SUBDIVISION REPORT - CONCEPT/DEVELOPMENT PLAN

► **FILE #:** 11-SB-24-C

► **SUBDIVISION:** HARVEY LANE SUBDIVISION

HARVEY LANE SUBDIVISION
1630 HARVEY ROAD (PARCEL 169 009)
KNOXVILLE, TN 37922
CONCEPT LAYOUT AND PAVING PLAN
PLANNING FILE NUMBERS: 11-SB-24-C / 11-B-24-DP

C1.00
CONCEPT

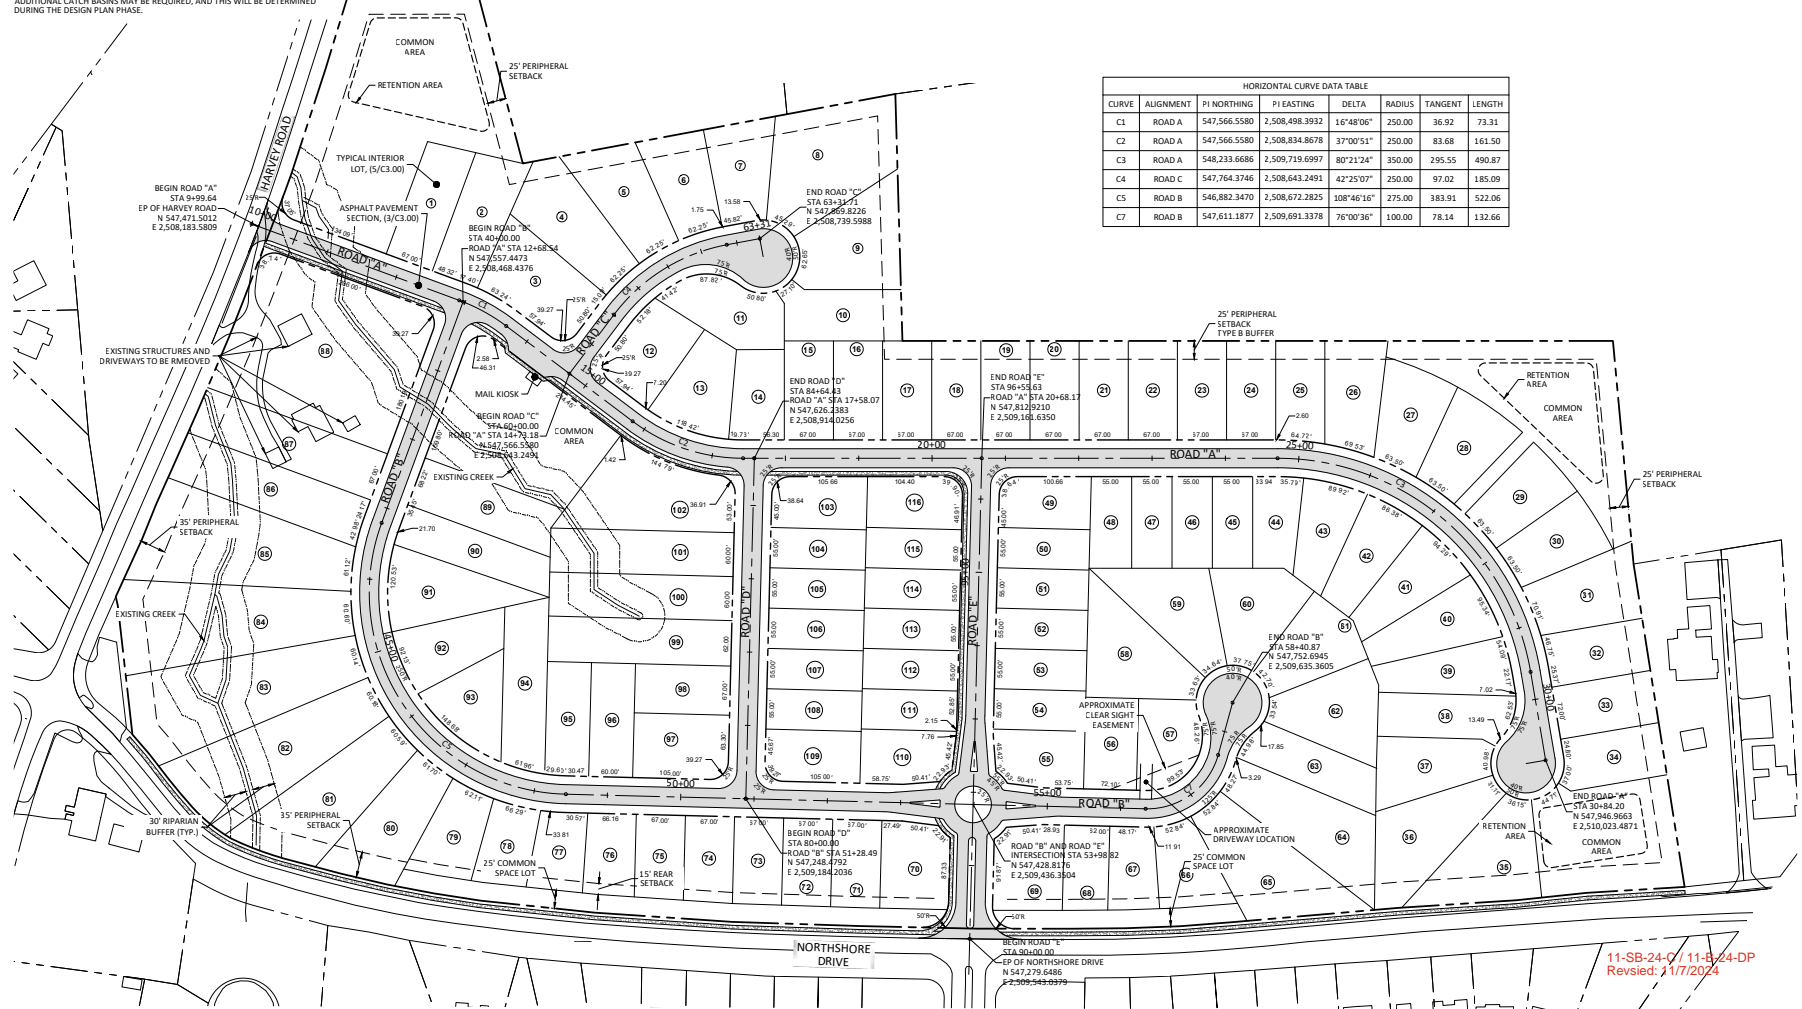
1. Reduce the minimum horizontal curve radius on Road 'B' from 250 ft to 100 ft at curve C7.

- **Approve the development plan for up to 116 detached residential lots and reduction of the 35 ft peripheral setback to 25 ft along the north and east boundaries and with the common area lots with 25 ft depth along the Northshore Drive frontage, subject to 3 conditions.**

The applicant requests to reduce the minimum horizontal curve radius from 250 ft to 100 ft on Road 'B', east of the roundabout. While the full length of Road 'B' exceeds 1,000 ft, requiring a minimum 250 ft radius, the road length from the roundabout is only about 450 ft. Roads less than 1,000 ft require a minimum 100 ft radius. In addition, sight distance easements are required through the inside of curves with less than 250 ft radius to ensure sight lines remain clear. The applicant also requests to increase the maximum intersection grade from 1% to 1.5% for one intersection and 2% at four intersections. Knox County Engineering and Public Works can approve an intersection grade of up to 2% when there is a crosswalk and 3% when there is no crosswalk.

- **Approve the alternative design standard based on the justification provided by the applicant and recommendations of the Knox County Department of Engineering and Public Works.**

- 1) Meeting all other applicable requirements of the Knox County Zoning Ordinance.
- 2) Providing a Type B landscape screen (Exhibit C) along the north and east boundary where the peripheral setback is reduced to 25 ft.
- 3) Providing a Type C landscape screen (Exhibit D) along the Northshore Drive frontage. Existing trees that remain can count toward this requirement. A detailed landscape plan must be submitted to Planning staff for review and approval before grading permits are issued.

C3.00
CONCEPT

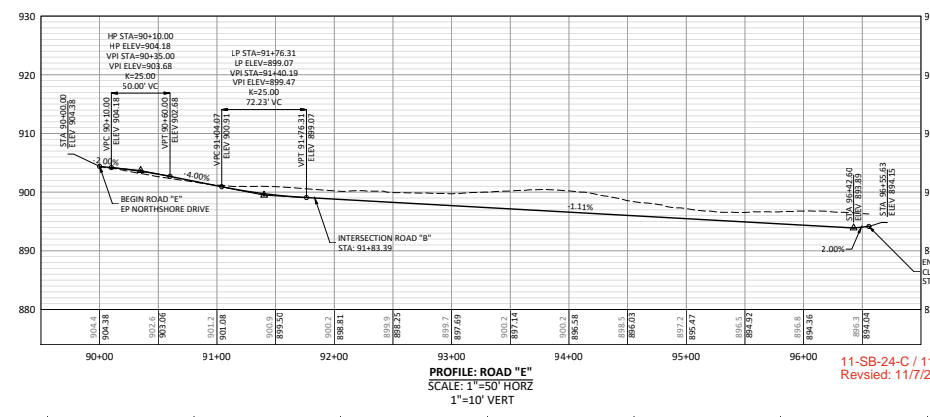
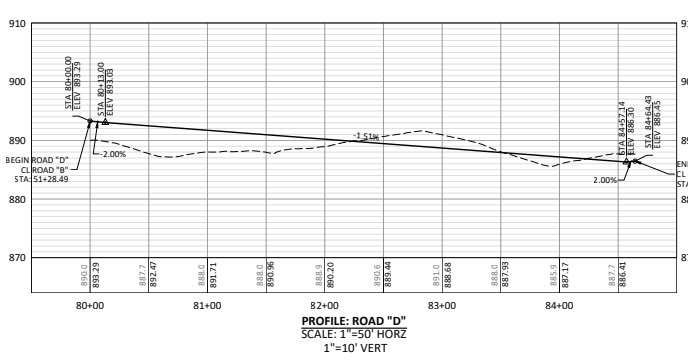
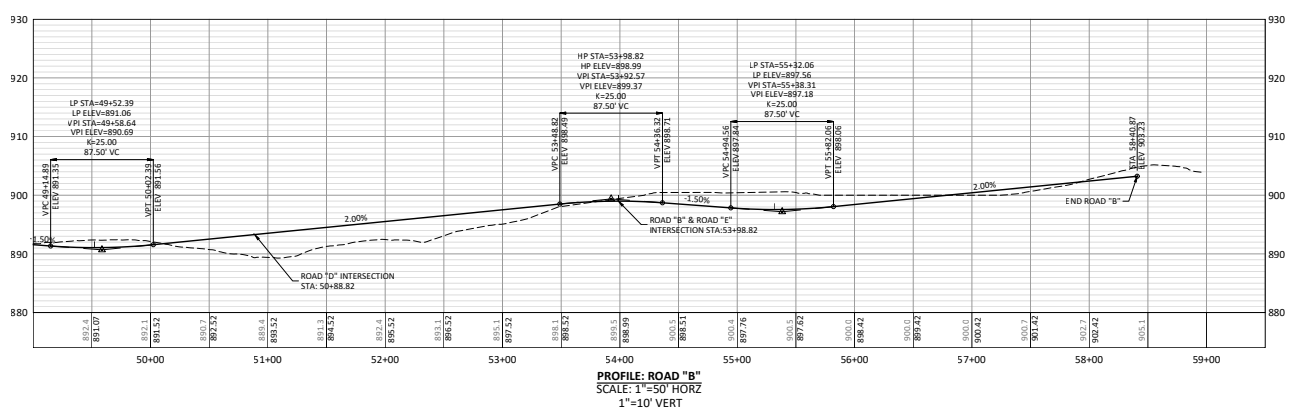
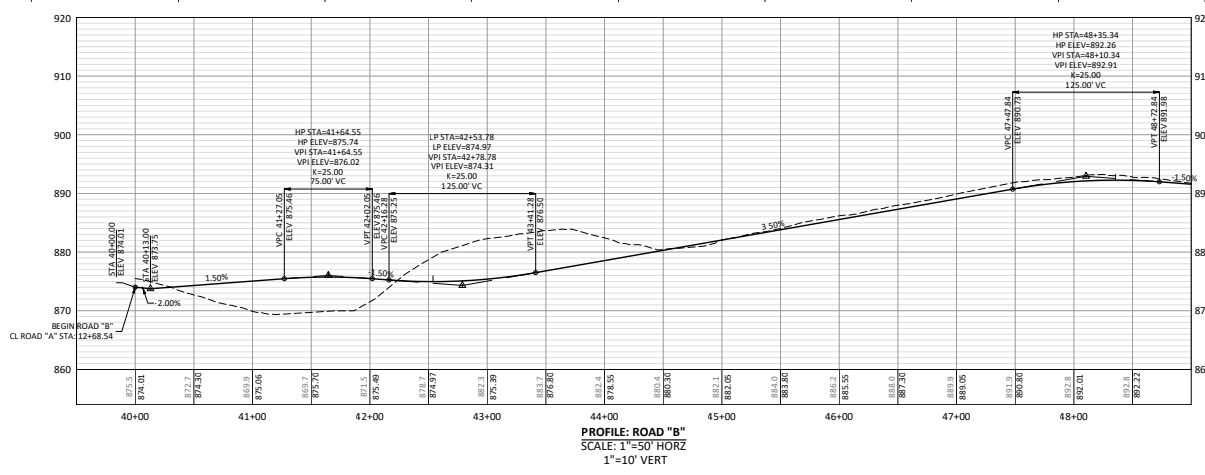
- 1. Increase the maximum intersection grade from 1% to 2% on Road 'C' at Road 'A'.**
- 2. Increase the maximum intersection grade from 1% to 2% on Road 'B' at Road 'E'.**
- 3. Increase the maximum intersection grade from 1% to 1.5% on Road 'D' at Road 'B'.**
- 4. Increase the maximum intersection grade from 1% to 2% on Road 'E' at Road 'A' and Northshore Drive.**

Increase the intersection grade from 1% to 2% on Road "C" at the intersection of Road "A"

Increase the intersection grade from 1% to 2% on Road "B" at the intersection of Road "E"

Increase the intersection grade from 1% to 1.5% on Road "D" at the intersection of Road "B" and Road "A"

Increase the intersection grade from 1% to 2% on Road "E" at the intersection of Road "A" and Northshore Drive

Engineering supports the alternative design standard requested

(to be completed during review process): YES ☒ NO ☐

Engineering supports the alternative design standard requested

(to be completed during review process): YES ☒ NO ☐

Engineering supports the alternative design standard requested

(to be completed during review process): YES ☒ NO ☐

Engineering supports the alternative design standard requested

(to be completed during review process): YES ☒ NO ☐

Engineering supports the alternative design standard requested

(to be completed during review process): YES ☒ NO ☐
